FLIGHT CONTROLS - GARMIN GSM 86 ELEVATOR TRIM MODIFICATION

525B (CJ3+)

The current continuous travel capstan design may cause the elevator trim bridle cable to slip.

SB525B-27-05  
Page 1 of 8

Figure 1. Installation Of The Elevator Trim Capstan and Servo Mount (Sheet 1)

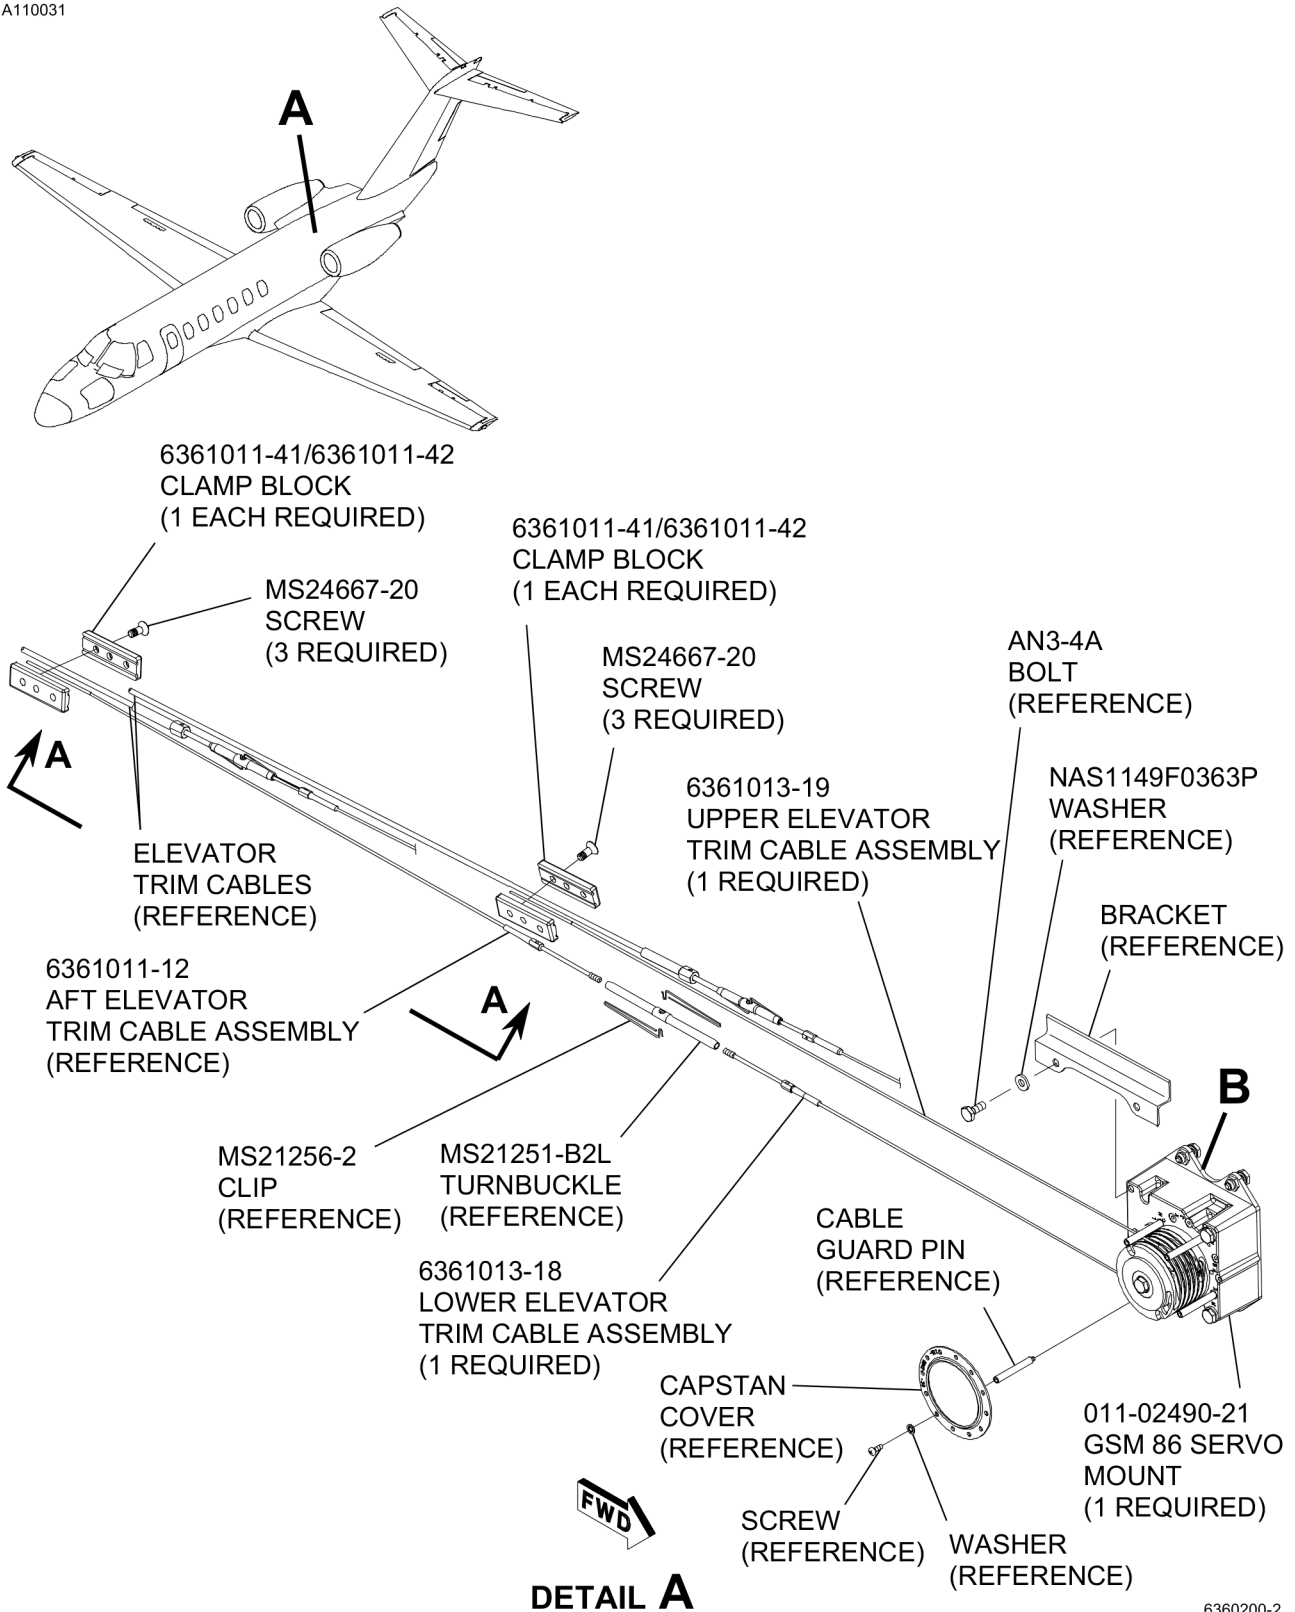
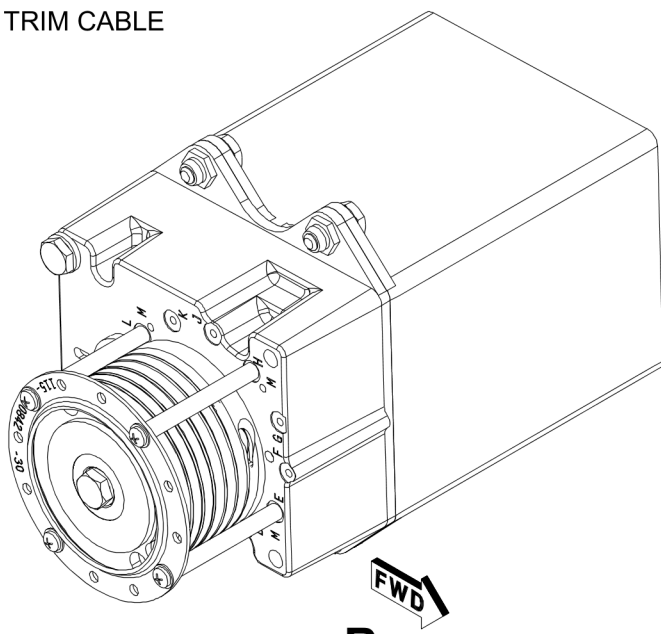
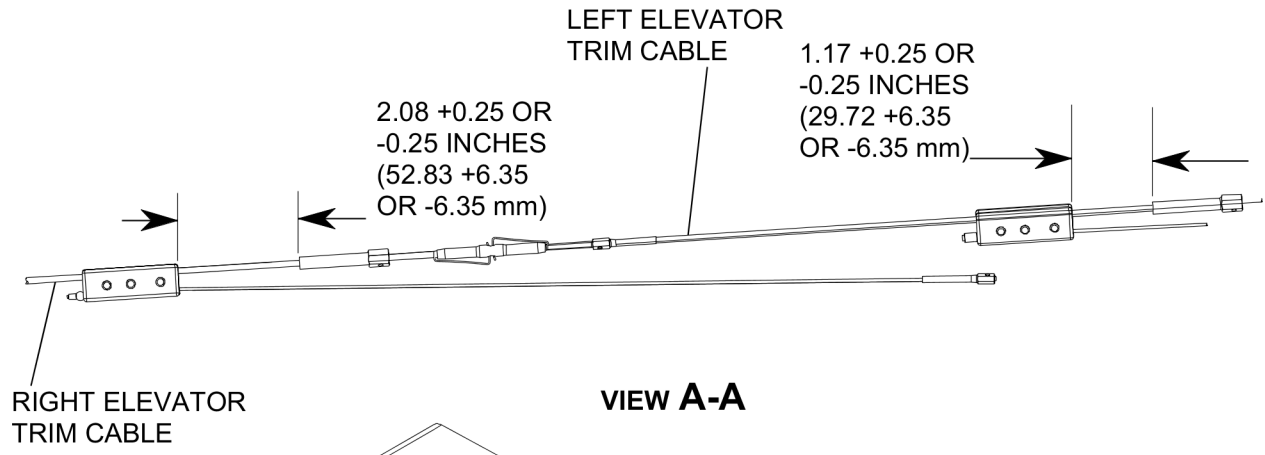
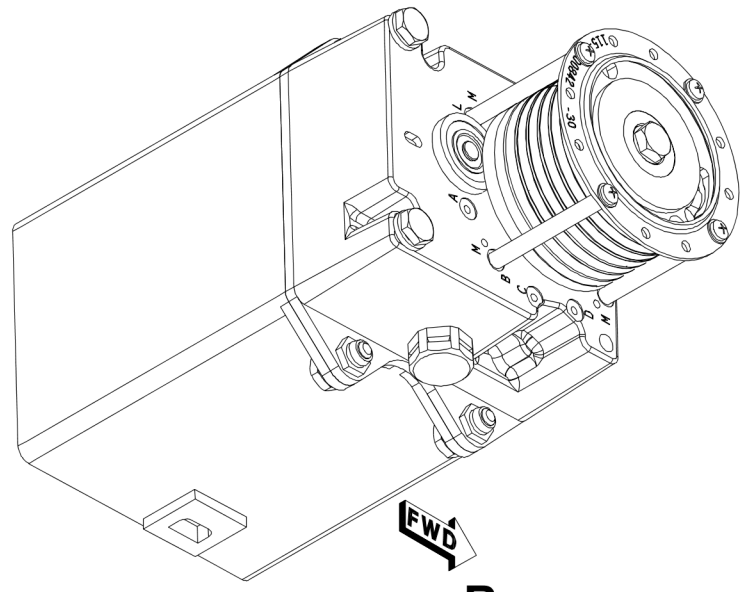
This service bulletin provides parts and instructions to remove the current elevator servo mount and elevator trim cables and install an improved design.

6. (Refer to Figure 1). Install the 011-02490-21 GSM 86 Servo Mount.
- A. Remove and keep the capstan cover screws, washers, capstan cover and five cable guard pins.

- (1) (Refer to Figure 1, Sheet 2). Make sure that the cable guard pins are located at B, E, H and L.
  - D. Put the kept capstan cover in its position on the cable guard pins.

**NOTE:** (Refer to Figure 1, Sheet 2). The forward edge of the forward clamp block is  $1.17 \pm 0.25$  inches ( $29.72 \pm 6.35$  mm) from the edge of the left aft elevator trim cable terminal.

**NOTE:** (Refer to Figure 1, Sheet 2). The forward edge of the aft clamp block is  $2.08 \pm 0.25$  inches ( $52.83 \pm 6.35$  mm) from the edge of the right aft elevator trim cable terminal.

NOTE: THE CABLE GUARD PINS SHOULD BE LOCATED AT B, E, H AND L.
